ENDL TEXAS

Date: 19 June 2008
 To: SNIA OSD TWG and T10 Technical Committee
 From: Ralph O. Weber
 Subject: OSD-2 CDB Continuations Definition and Usage

Figure 4 — OSD security model transactions

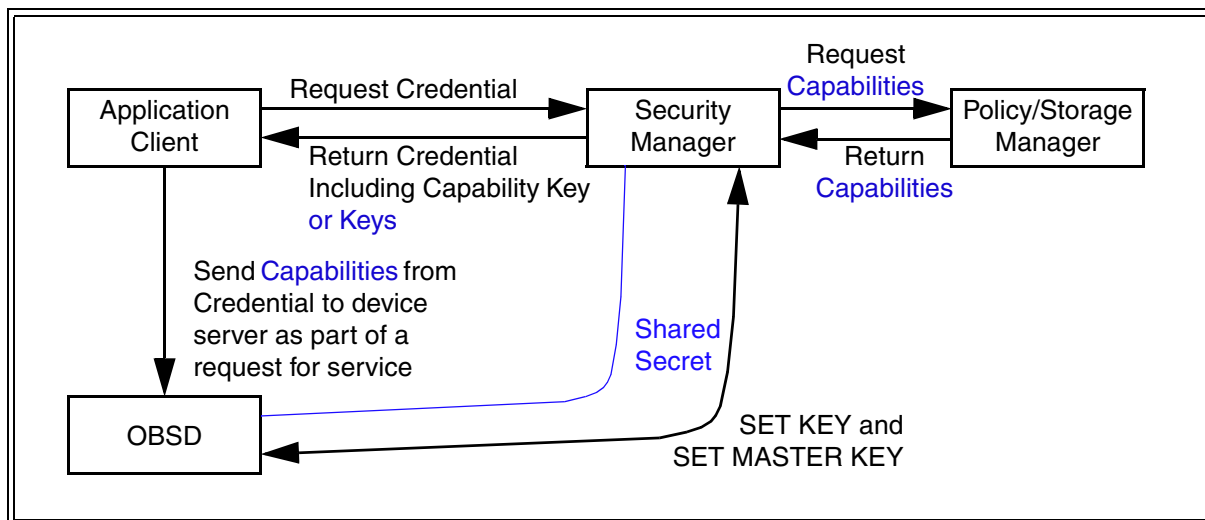
{{With the exception of 'Shared Secret', all the blue text in figure 4 is a replacement for existing text. To keep figure 4 manageable, strikeouts are not show for the old text.}}
